**APPLICATION FOR A DLNR DAM SAFETY CONSTRUCTION/ALTERATION PERMIT
PERMIT NO. 38 – KAPALAALAEA RESERVOIR (HI00094)
OUTLET PIPE REPAIR, PAIA, MAUI**

Subject: Response to comments on the Kapalaalaea Dam Repair Application – Dam Permit No. 38
DLNR DAM No. MA0094, Island of Maui, Hawaii – Memorandum of Design Review
dated March 17, 2009

Memorandum of Design Review

EXCAVATION AND BILL PROFILE

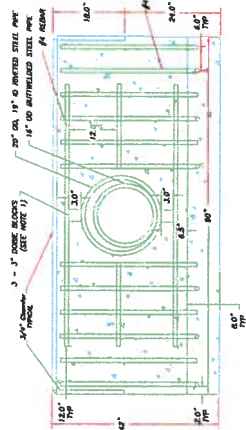
Comment: *The cut slope is probably too steep for the fill to be compacted against it effectively to meet the density requirements; use vibratory sheetfoot attachment to the backhoe or small compactor such as Wacker rammer to compact the edge of the lifts against the cut slope. For dam construction, stepping or benching is not recommended at the steep slope or at the edge of each horizontal lift.*

Comment: *Note 1 – Provide the types of compacting equipment to be used and the types and the frequency of soil density test if performance specifications are to be used. We recommend compacting the backfill to the same density as that of the exiting embankment.*

Comment: *Note 2 – A 12-inch minimum initial fill over the crown of the pipe may be too thick to obtain the specified relative compaction.*

Comment: *Note 4 – Provide the specification of the flowable fill.*

Comment: *Provide the type of material and compaction method to be used between the springline of the pipe and the top of the flowable fill.*

Follow-up Comments on Sheet No. C2, Section B regarding stepping or benching

Small compacting equipment should be used to compact the toe or the bottom of the bench or step to reach the required relative density.

Response: We will use a vibratory sheetfoot attachment to the backhoe if available, or a small compactor to compact the edge of the lifts against the cut slope. While benching the excavation is not optimal, safety concerns require that the slope be benched. The benches will be scarified to provide a good bonding surface for the overlying fill. In addition, the fill will be arranged so that the horizontal benches are at mid depth of the adjacent fill lift – i.e., the top of the first lift below the bench will be 4 inches below the bench and the next lift will extend 4 inches above the bench.

Response: A small compactor, such as reversible plate compactor or rammax roller, will be used to compact the soil to the same density as the existing embankment, or as deemed acceptable by geotechnical engineer. A nuclear gage density test will be used after compaction to ensure that the proper compaction has been achieved.

Response: LFR agrees. The note has been changed to indicate a 4-inch lift over the crown of the pipe.

Response: See above response.

Response: See above response.

DRAWN BY: HMK
REVIEWED BY: BKH
REVISION NO.: 1
ORIGINAL ISSUE DATE: 03/18/09
PROJECT NO.: 000-1200-02
SHEET NO.: C3

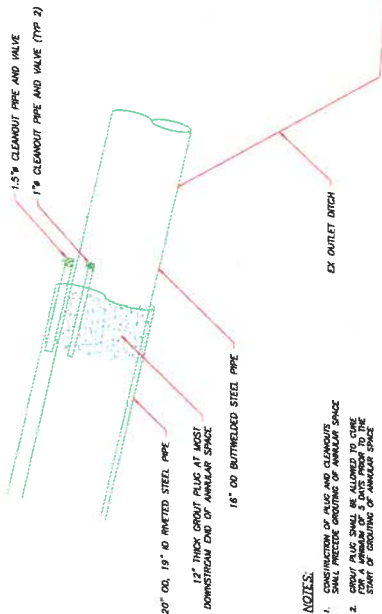
Comment: *Detail A shows a 12-inch thick headwall; Detail C on Sheet C3 shows a 9-inch thick wall. Need clarification and revision.*

Comment: *The space between vertical #4's is less than two inches as detailed. For 9-inch wall, consider using one layer of reinforcement with every other hook pointing to the opposite directions in the footing.*

Comment: *Provide temperature and shrinkage control reinforcing steel properly placed in both directions of the headwalls to provide crack control. We recommend providing horizontal #4's at 12 inches.*

Response: Detail C on Sheet C3 showing a 9-inch thick wall is correct. Detail A has been corrected to show a 9-inch thick wall.

Response: LFR agrees. The detail has been changed to indicate a single layer of vertical reinforcement with every other hook pointing to the opposite direction in the footing.

Response: LFR agrees. The detail has been changed to add additional horizontal #4 rebars at two levels in the foundation.
